SHEET SIZE= C	DRAWN BY: F.S.B.	PART NUMBER or STYLE:	
SCALE = 1":1"	DATE DRAWN:	C10 5ft Stair Section	
STANDARD TOLERANCE:	2/10/2015	Quote requested by:	
.00 ±.01 FRACTIONS:	LOC:		
.000 ±.005 ±1/16"	Z:\Aluminum\Westbury\C10		
ANG. ±.5°	Tuscany\Section\Stair		
FIRST USED ON:	DRAFT:	PART NAME:	SHEET REV.
	20141001-3F	C10 Tuscany	of B

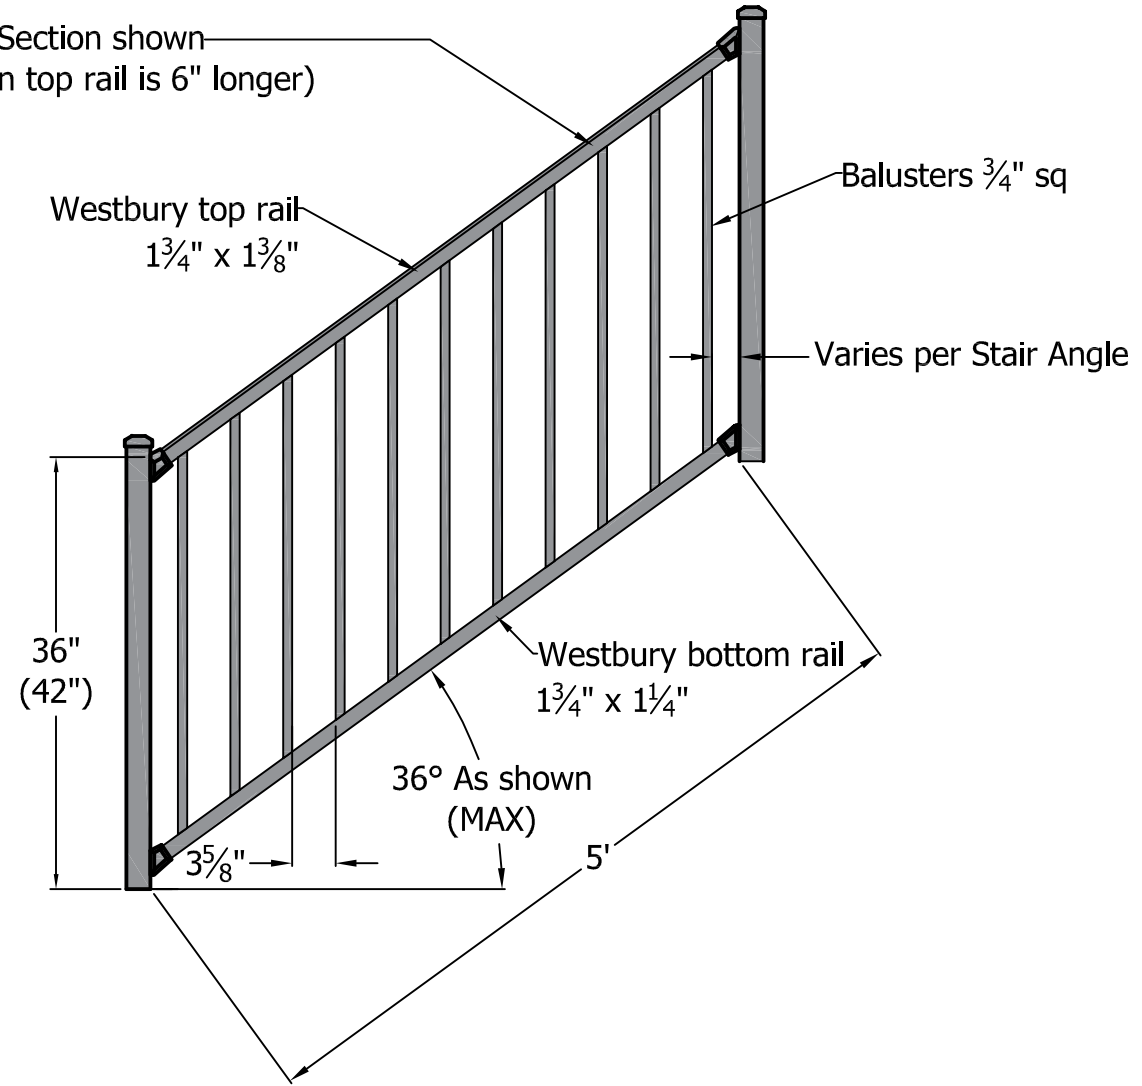
REV.	LOC.	REVISION	DATE
A		RELEASE PENDING APPROVAL	
B		Baluster spacing 3.625. Increased hole size to accomodate 36" stairs.	2/11/15
